## PLANNING COMMISSION STAFF REPORT

Originator <b>Cary Teague</b> Community Development Director	Meeting Date <b>April 9, 2014</b>	Agenda # <b>VI.B.</b>
---	--------------------------------------	--------------------------

Border Foods Inc. is proposing to tear down the existing Taco Bell restaurant and rebuild a new slightly smaller Taco Bell at 3210 Southdale Circle. (See property location on pages A1–A3.) The building would be 1,850 square feet in size. (See applicant narrative and plans on pages A4–A26.) To accommodate the proposal to redevelop the site, the applicant is requesting a Site Plan review and the following Variances:

New Building  
 N1-29, 29 Seats: 1,847 SF  
**SITE PLAN**

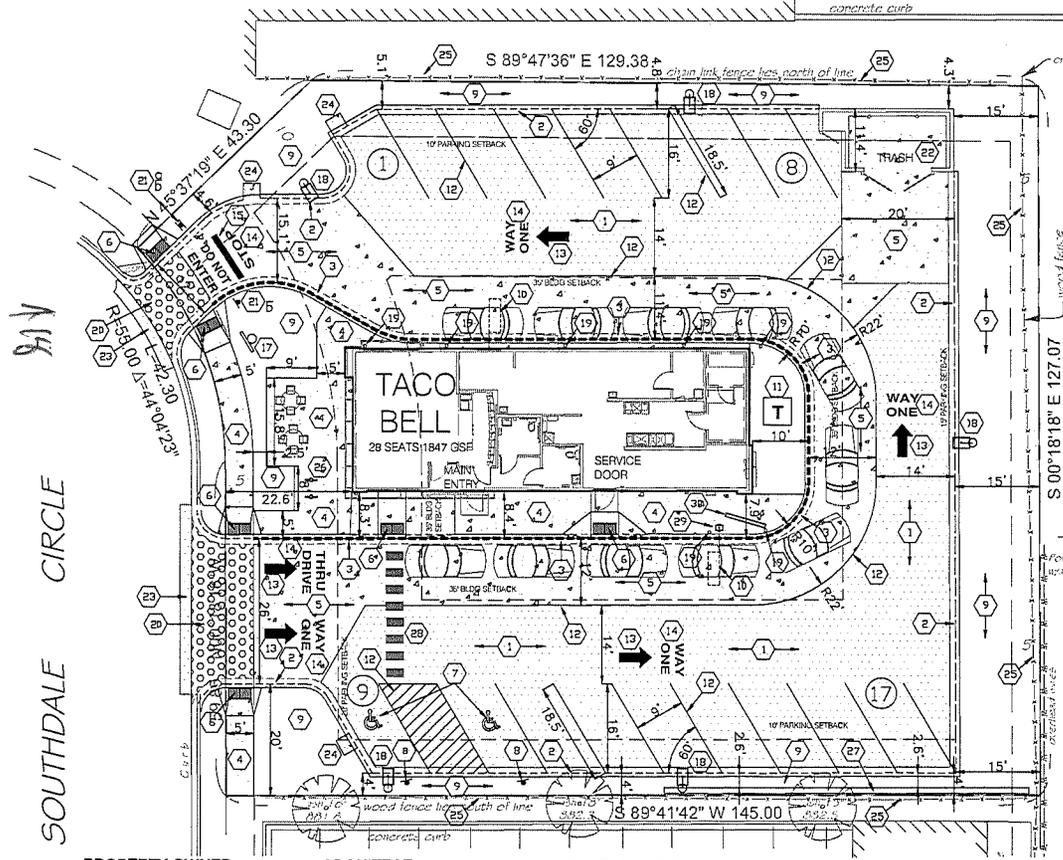
**Date:** April 2, 2014  
**To:** Cary Teague – Community Development Director  
**From:** Chad Millner – Director of Engineering  
**Re:** 3210 Southdale Circle – Taco Bell Re-Development  
Plans Dated March 7, 2014

Engineering has reviewed the above stated proposed plan and offer the following comments:

- A Nine Mile Creek Watershed permit will be required; along with potential other agency permits such as MNDH, MPCA, and MCES.
- The City will consider the water and sanitary sewer pipes private utilities and the responsibility of the property owner for future maintenance and repair. The private water service begins at the gate value and the private sanitary sewer service begins at the sanitary sewer trunk pipe, both located in Southdale Circle.
- A set of as-built plans will be required with the final C.O.
- Details are needed on the infiltration system such as expected infiltration rates. This would be part of the watershed permitting process.
- Indicate on plans what utilities are private versus public by noting that on the pipes.
- Construct utilities per City of Edina Standard Details.
- Watertight sanitary sewer castings are required on all sanitary sewer manholes / cleanouts.
